# Wisconsin Department of Transportation

**Proposal #44: 8142-00-70, WISC 2022261**  
**STH 35 – Clear Lake**  
**CTH PP to Pondhurst Drive**  
**CTH F**  
**Polk County**

This is Addendum No. 02, which provides for the following:

Addendum No. 02  
ID 8142-00-70  
Revised Sheet 8  
March 1, 2022

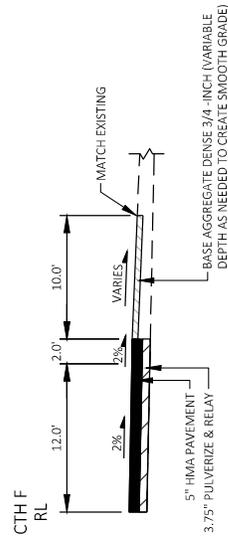
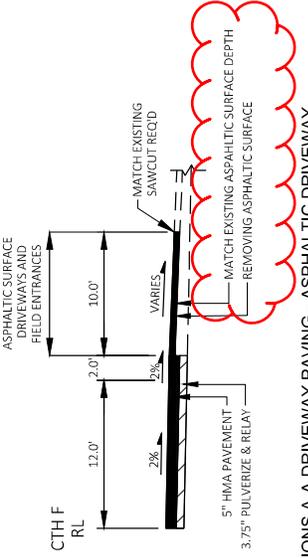
Revised Plan Sheets	
Plan Sheet	Plan Sheet Title (brief description of changes to sheet)
8	Construction Details (detail for asphaltic driveways updated to clearly call for the Removing Asphaltic Surface item and to keep the depth of asphalt called for equal to the existing asphaltic driveway depth in all cases)
12	Miscellaneous Quantities (added a table for Removing Asphaltic Surface to account for asphalt driveway removals)

SECTIONS A-A DRIVEWAY PAVING - GRAVEL DRIVEWAY

SECTIONS A-A DRIVEWAY PAVING - ASPHALTIC DRIVEWAY

- STA 56+15 LT
- STA 111+78 LT
- STA 119+66 LT
- STA 131+95 RT
- STA 136+66 LT
- STA 135+93 RT
